PD Modification Application PRS 21-0826

Hillsborough County Florida

Development Services Department

Request Minor Modification to PD

2.5 Proposed Site Plan

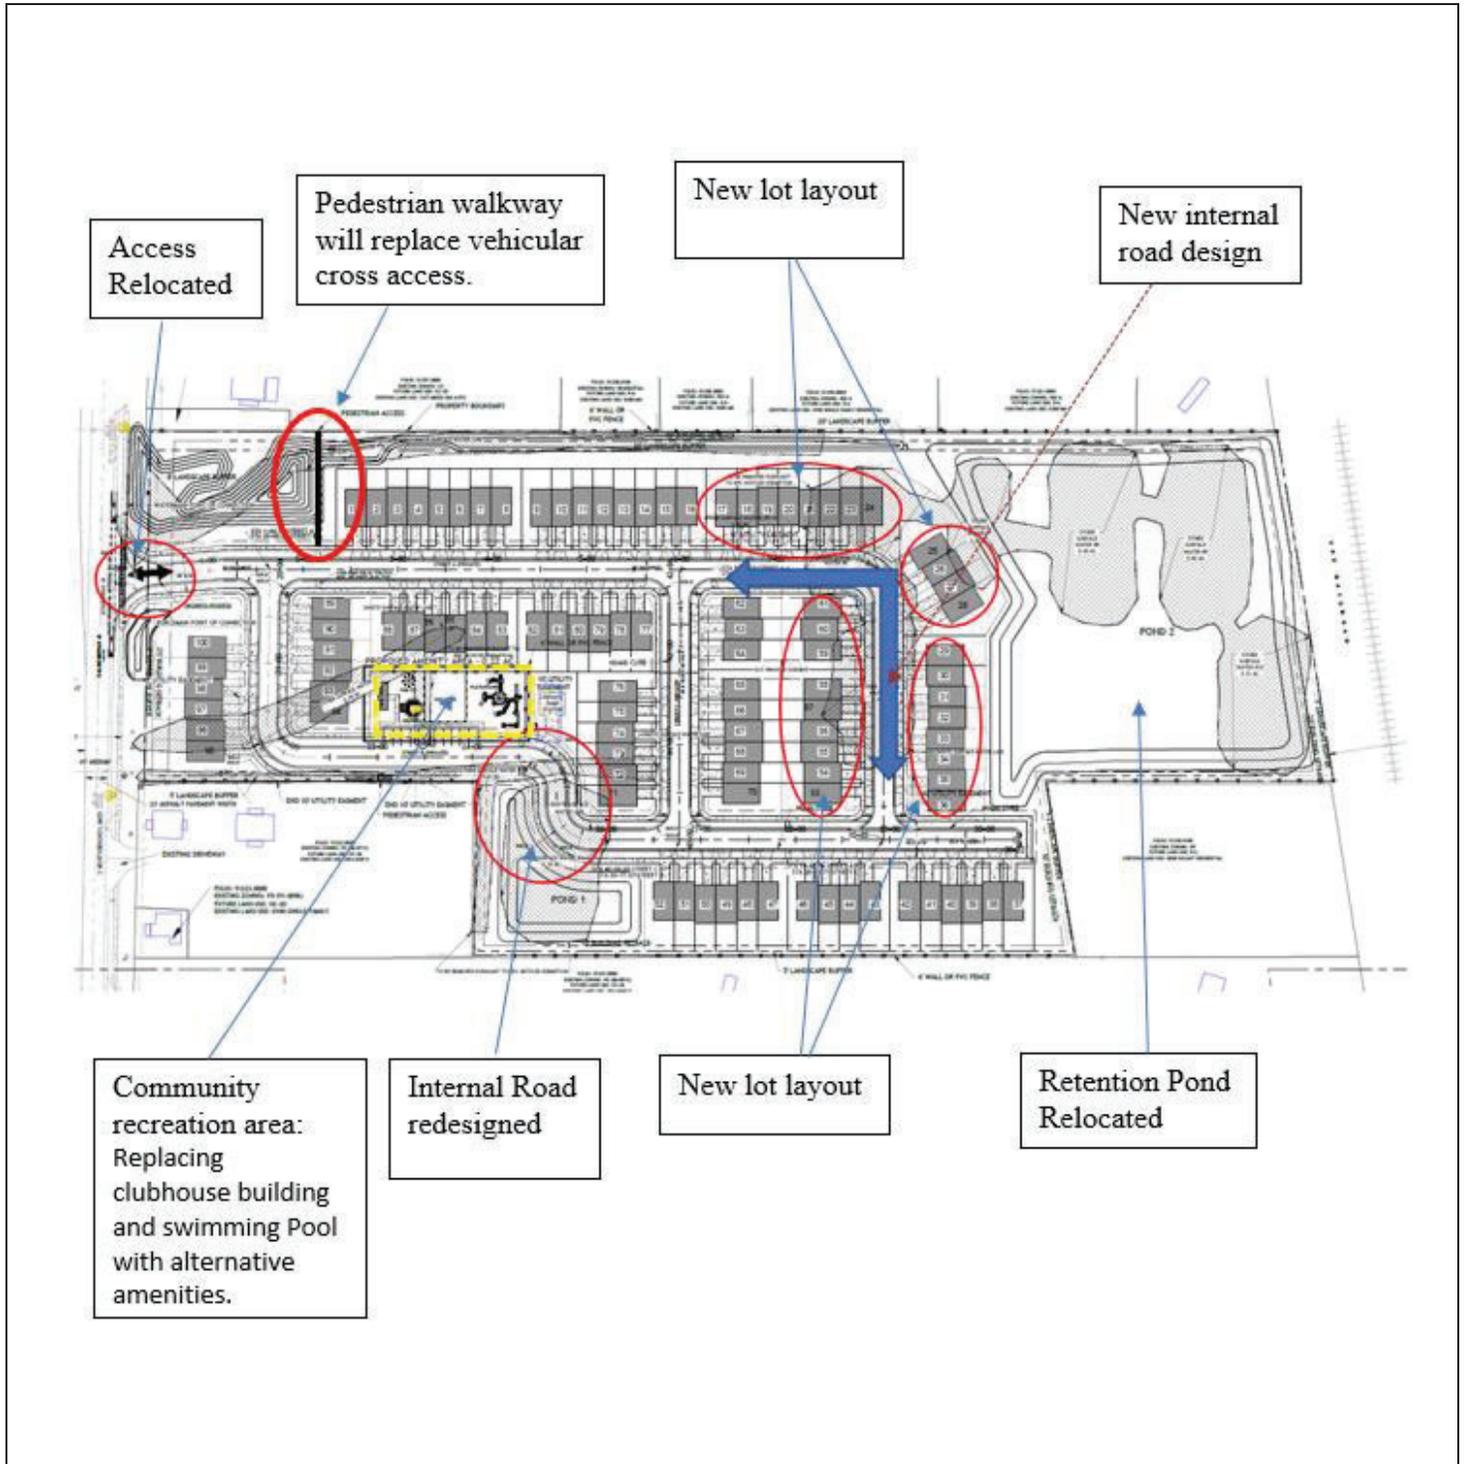
Prior to PD Site Plan Certification, the applicant shall revise the PD site plan to replace all references to streets internal to the project site with "private driveway".

[Staff recommends this revision to clarify that the references to streets within the proposed PD site plan (e.g. Street A, Street B, Street C) are not public or private streets as they not consistent with the Hillsborough County Transportation Technical Manual typical section for private residential roads.]

US41 PD&E STUDY
 Kracker Ave to South of Causway Blvd (SR676)
 Concept Plans
 WPI SEGMENT No. 430056-1

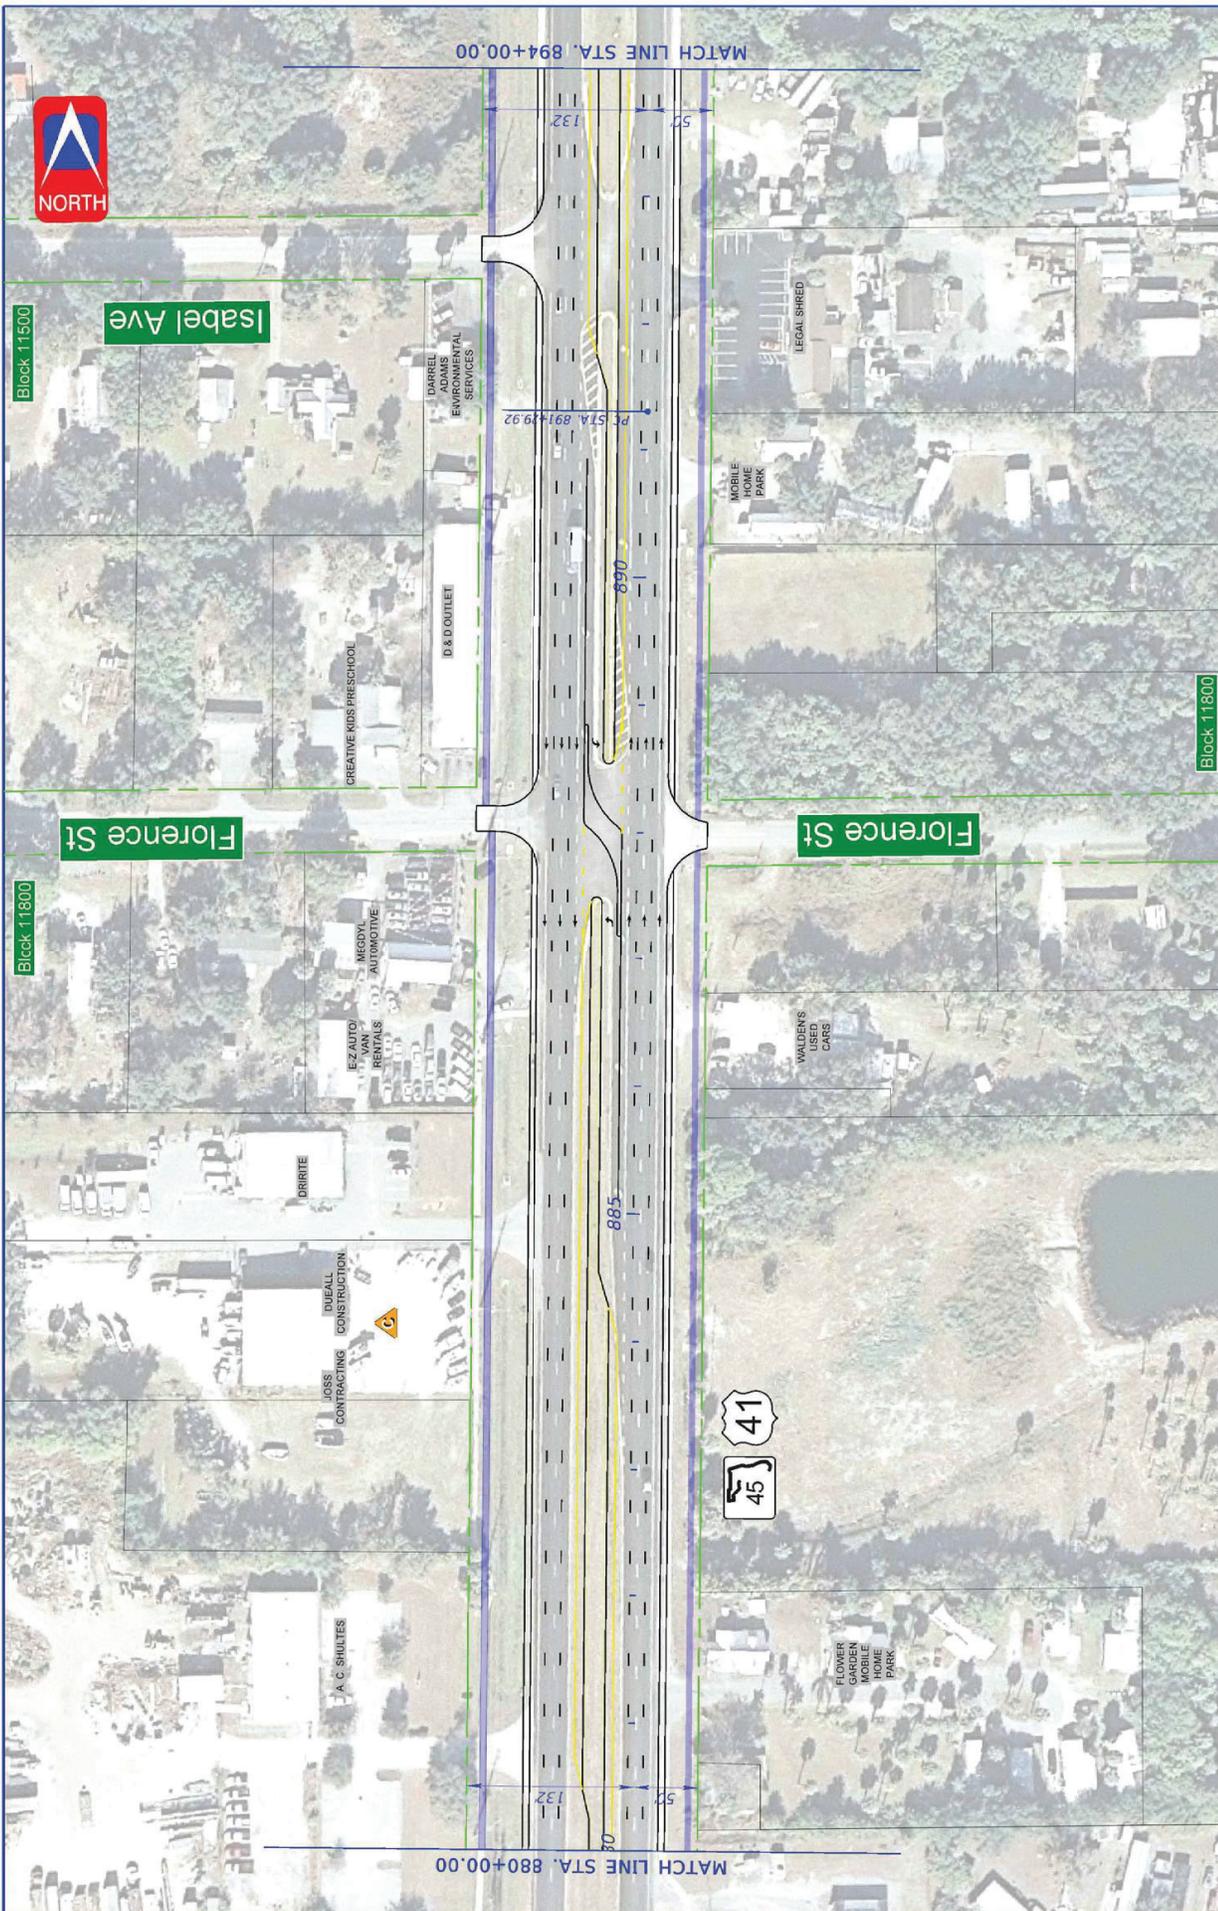
FDOT conducted a Project Development & Environment (PD&E) study to consider widening a portion of US 41 from Kracker Avenue to South of Causeway Blvd (SR 676). The concept page from the PD&E is attached.
